HISTORIC DISTRICT REVIEW BOARD REGULAR MEETING AGENDA

Agenda Item: APPLICATION FOR AN ADDITION, HDRB #25-008, to consider an application for a Certificate of Appropriateness for the addition of a mudroom that will partially enclose an existing porch at the single-family residential building located at 631 Nash Street, Herndon, Virginia.

Subject: APPLICATION FOR AN ADDITION, HDRB #25-008, to consider an application for a Certificate of Appropriateness for the addition of a mudroom that will partially enclose an existing porch at the single-family residential building located at 631 Nash Street, Herndon, Virginia.

| SHEET NUMBER | A2.1 |

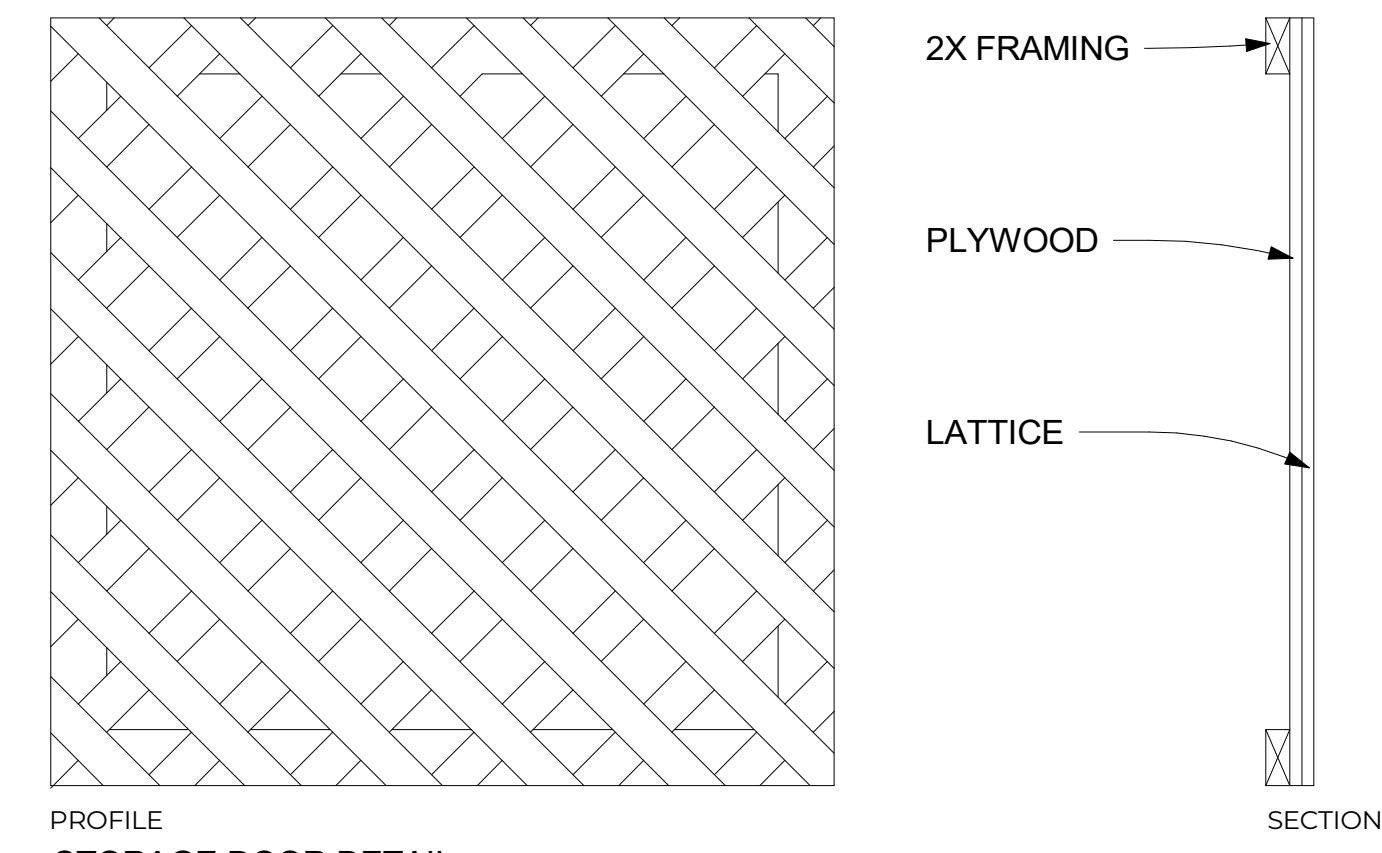
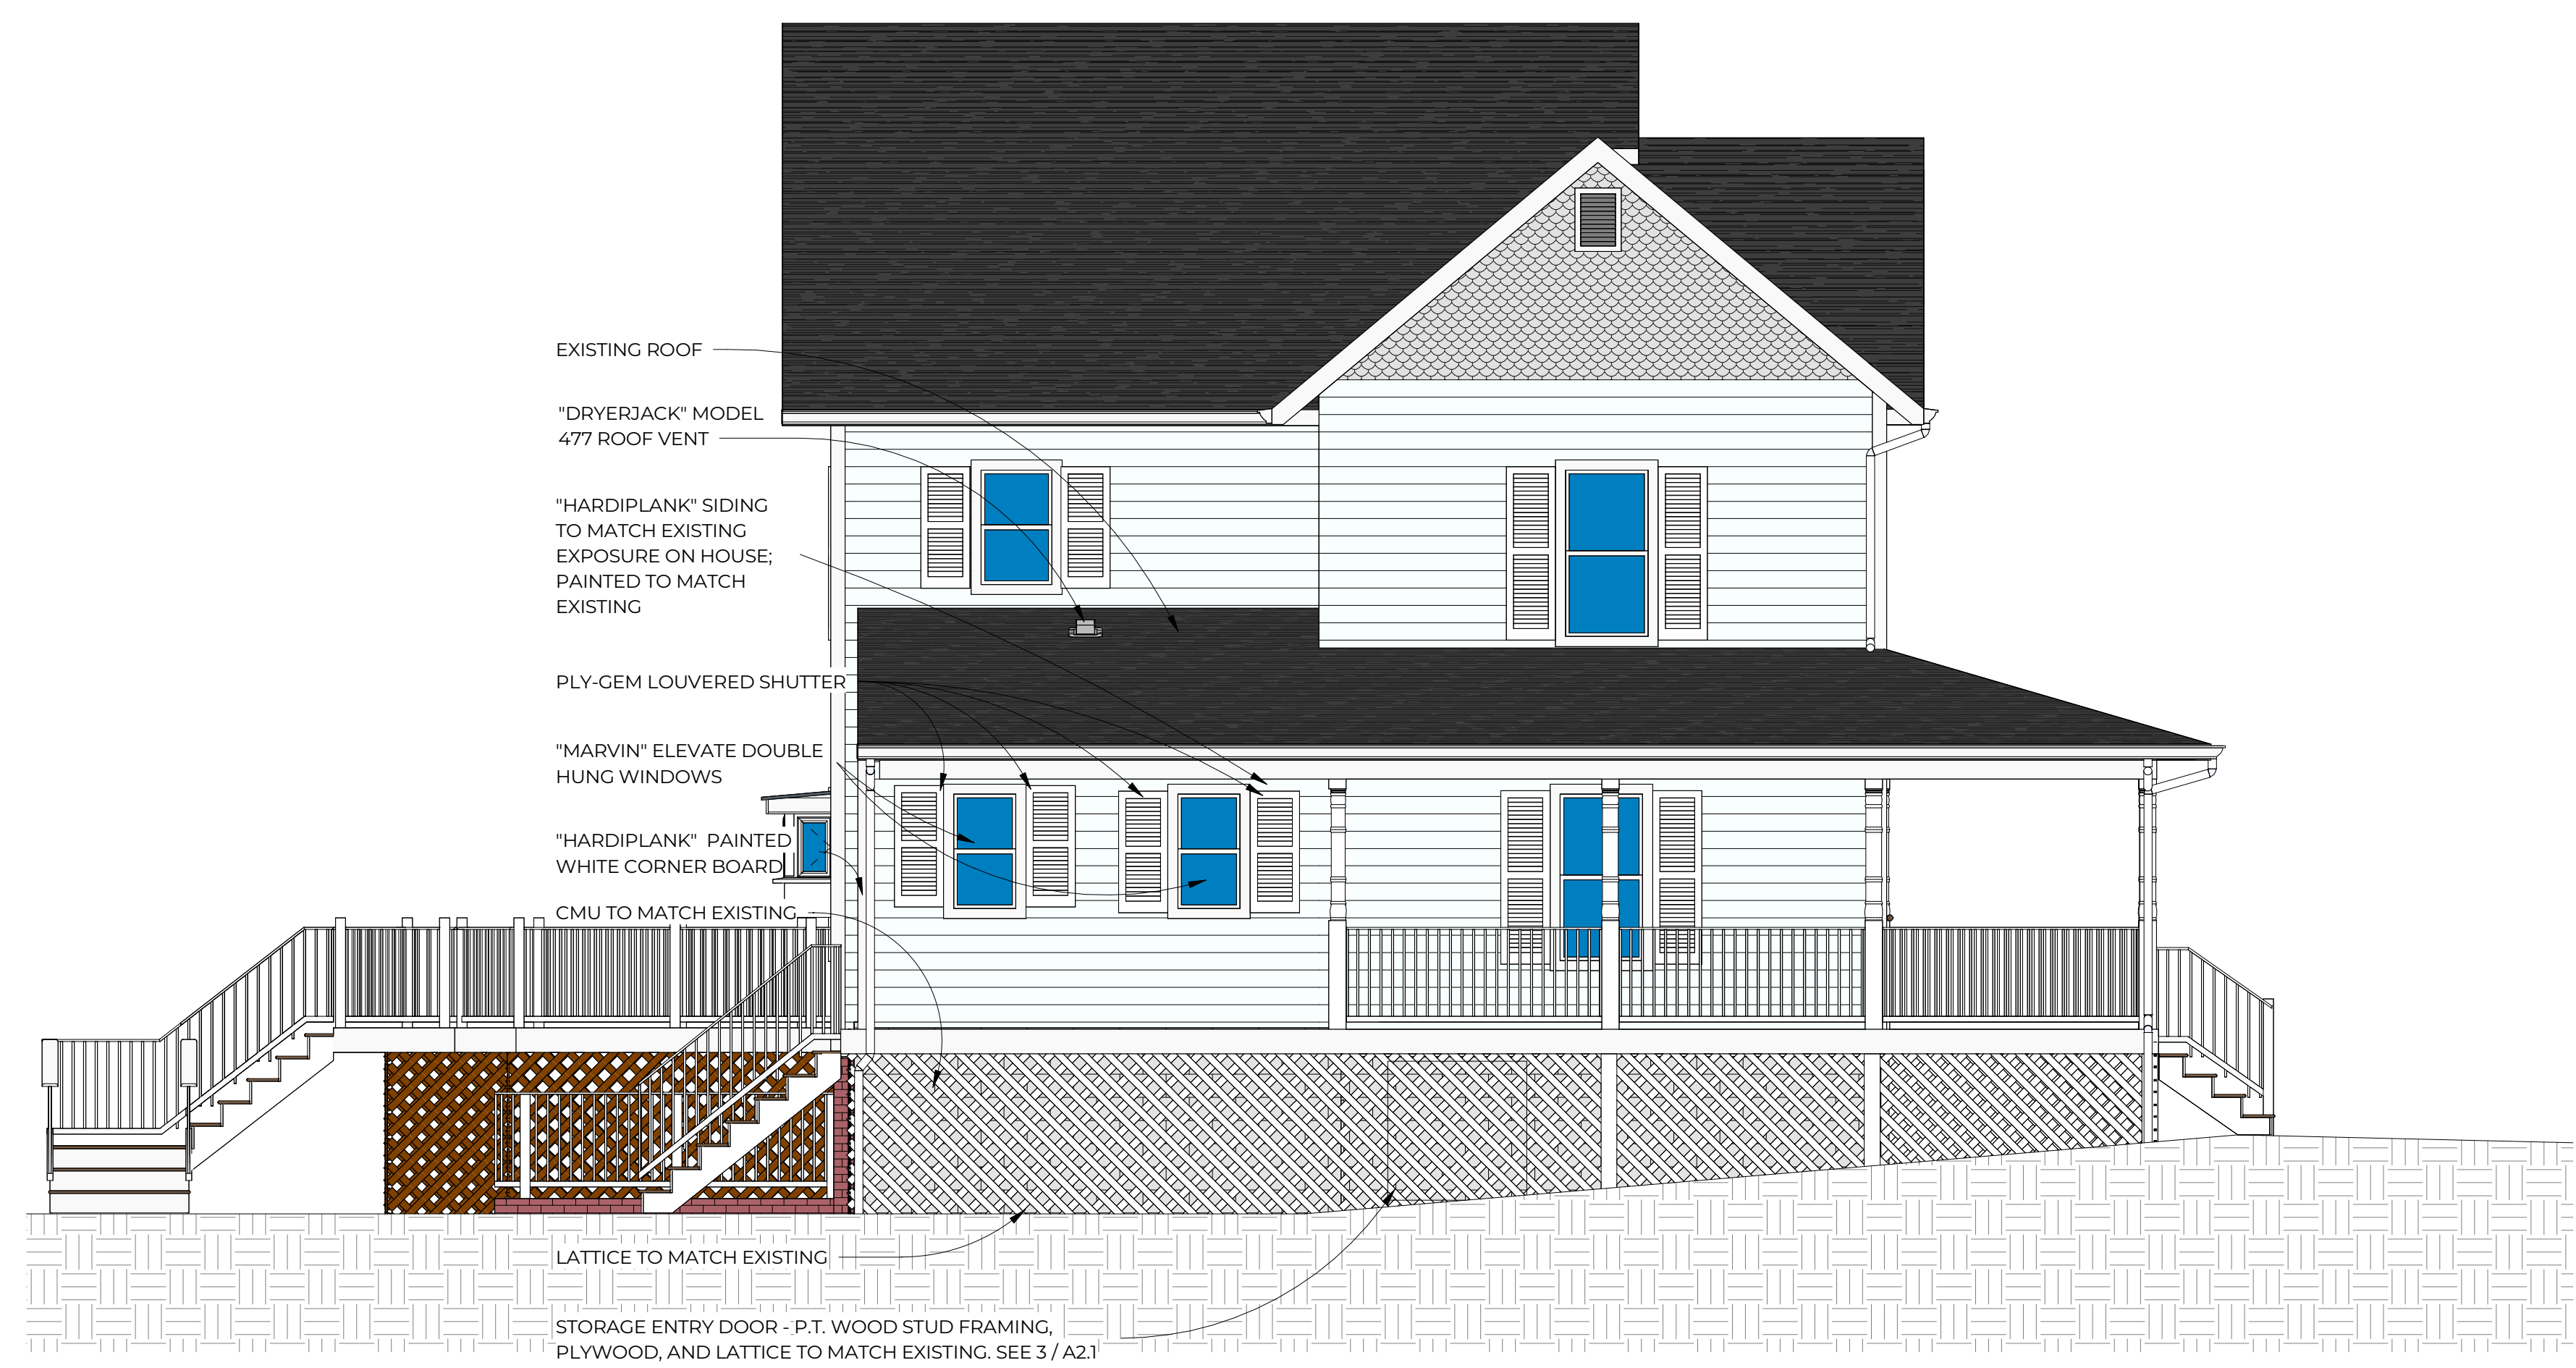
- Specifications for the storage entry door depicted on sheet A2.1.
- Further information is needed as to the material of the proposed Ply-Gem shutters to ensure that they are not vinyl. Solid vinyl is not appropriate for exterior materials within the Historic District Overlay.

- The revised drawings include an existing and proposed floor plan that demonstrates that four porch columns and associated railings will be removed from the exterior of the porch (A1.1). The drawing also shows that the vinyl siding on two exterior walls of the dwelling will be removed. These walls and a doorway will be converted to interior features as part of this modification. The door of the converted doorway will be reused as the exterior door of the addition.
- Detail 3 on sheet A2.1 shows that the storage entry door will be custom made, with 2x framing, faced with plywood and lattice to match the exterior.
